**National Emission Standards for Hazardous Air Pollutants  
from the Pulp and Paper Industry (40 CFR Part 63, Subpart S)  
Residual Risk and Technology Review, Final Amendments**

**Response to Public Comments on  
December 27, 2011 Proposal**

U.S. Environmental Protection Agency  
Office of Air Quality Planning and Standards  
Sector Policies and Programs Division  
Research Triangle Park, NC 27711

July 2012

**Figure 1. EPA Calculation Methodology  
(Submitted by Commenter 0162)**

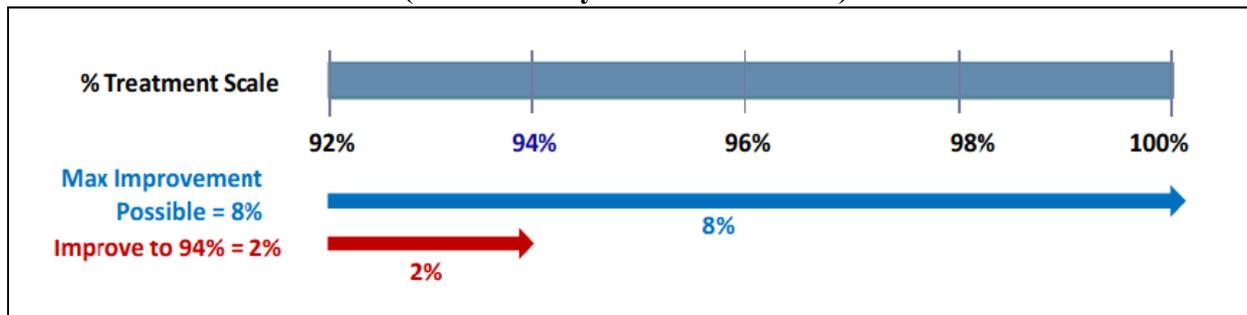
Commenter 0162 noted that in the equivalency calculation used to arrive at these numerical limits, EPA calculated the percent increase in control for each 1 percent increase in treatment efficiency from 92 percent to 98 percent (the level of control achieved for mills choosing the condensate recycling option). The commenter represented EPA’s rationale graphically in Figure 1 below:

Using this approach, the percent “standard improvement”<sup>116</sup> corresponding to an increase in treatment efficiency from 92 percent to 94 percent would be 2 percent of the maximum possible 8 percent =  $2/8 = 25$  percent. Using this approach, the percent “standard improvement” for each 1 percent increase in treatment efficiency (from 93 percent to 98 percent) would be:

- The percent “standard improvements” calculated above are, in effect, emissions reductions.
- In other words, a 2 percent increase in the numerical treatment efficiency standard is equivalent to a 25 percent reduction in associated remaining emissions.

**Figure 2. AF&PA Recommended Calculation Methodology  
(Submitted by Commenter 0162)**

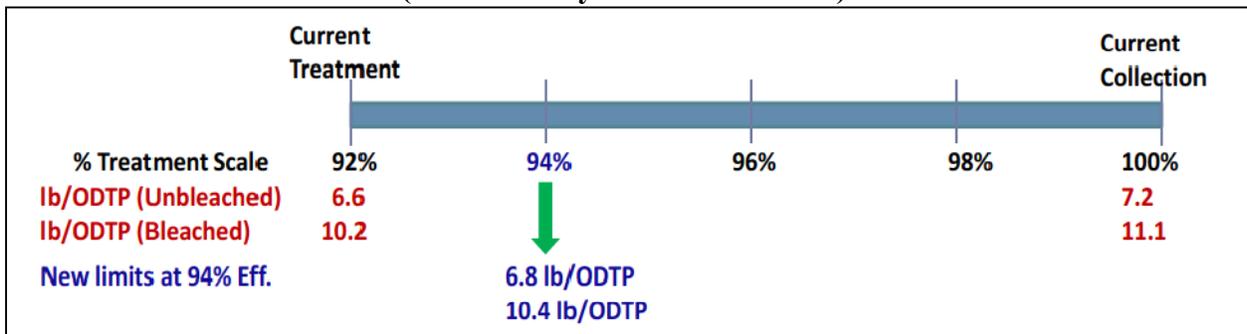
- When calculating numerical treatment limits, the applicable scaling factors should therefore reflect the original treatment scale and not the percent “standard improvement” (emissions) scale. As done in the original rulemaking, the lb/ODTP treatment requirement is simply calculated by multiplying the collection requirement by the proposed percent control efficiency, as shown in Figure 2 below.

Commenters 0162 and 0167 stated that the numerical treatment standards corresponding to the 94 percent treatment level can be calculated directly as shown below and are represented on the treatment scale in Figure 2 above.
